# HISTORIC AND DESIGN REVIEW COMMISSION July 17, 2019

**HDRC CASE NO:** 2019-274 **ADDRESS: LEGAL DESCRIPTION: ZONING:** RM-4, H **CITY COUNCIL DIST.:** 2 **DISTRICT: APPLICANT:** Mark Flinn **OWNER:** Mark Flinn **TYPE OF WORK:** July 01, 2019 **APPLICATION RECEIVED: 60-DAY REVIEW:** August 30, 2019 Huy Pham **CASE MANAGER:**

2019-274 1024 DAWSON ST NCB 1371 BLK 3 LOT E 38 FT OF 14 RM-4, H 2 Dignowity Hill Historic District Mark Flinn Mark Flinn Historic Tax Certification July 01, 2019 August 30, 2019 Huy Pham

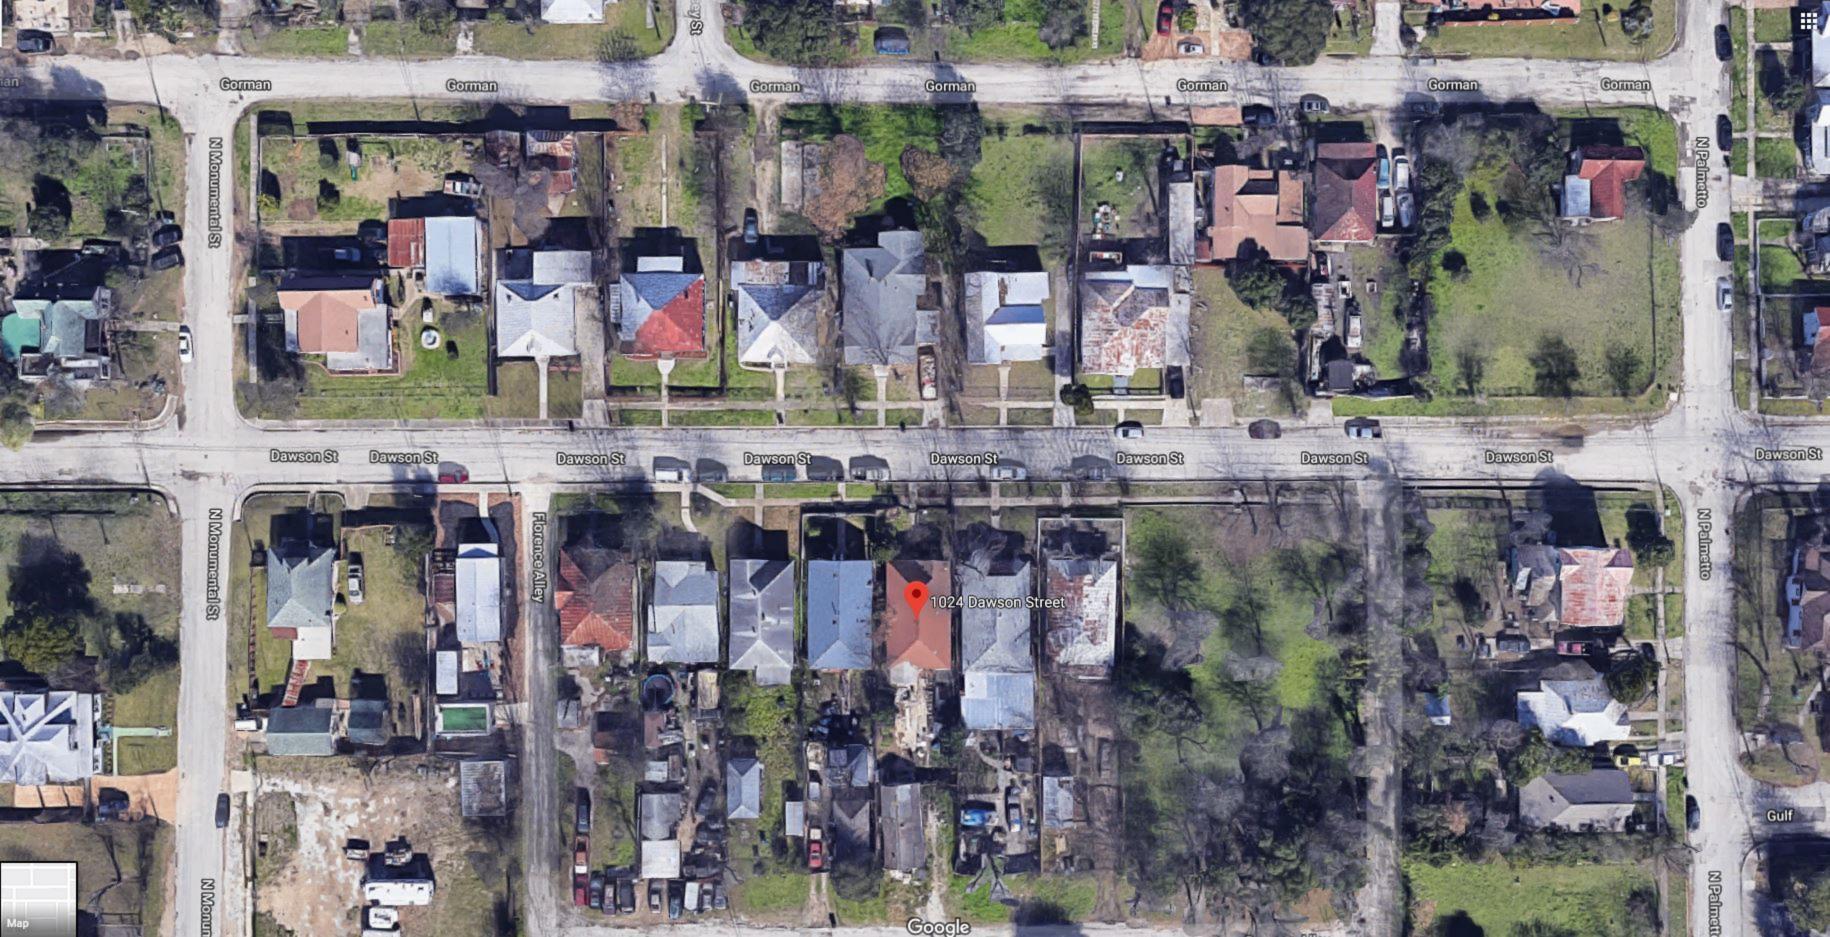
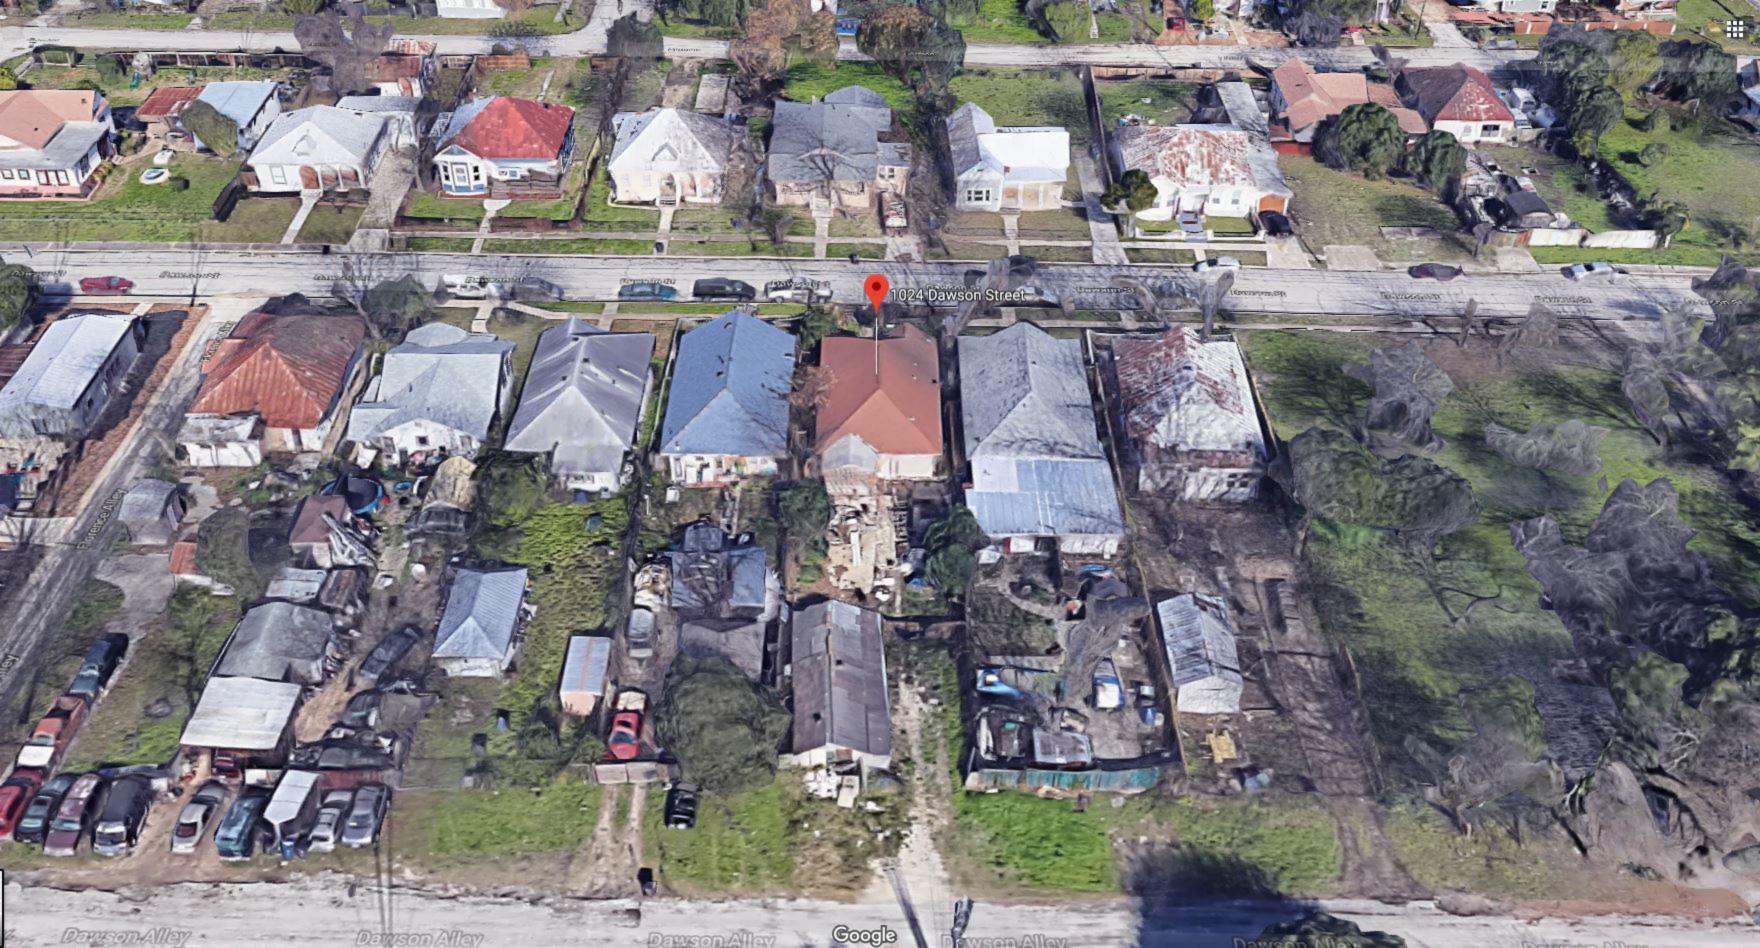
Previous owner -2018 - refer to infill middle window

Previous owner -2018 - refer to middle infill window Previous owner -2018 - refer to infill window

- original trim of full size window has been removed

- a shower/tub is behind the new smaller window

- original trim of full size window has been removed

- a shower/tub is behind the new smaller window

Previous owner installed door circa 2018 when removing front porch enclosure

- h. The two front vinyl windows are restored to their original material, size, and configuration. Specifications of replacement windows should be submitted to staff prior to installation.
- i. The side vinyl window is restored to its original material, size, and configuration. To accommodate the bathroom, this window may be enclosed from the interior by installing a furr wall. An elevation drawing and specifications of the window should be submitted to staff prior to construction.
- **j.** The ornamentation in the door's glazing should be removed or the whole door may be replaced with an appropriate Craftsman style door.
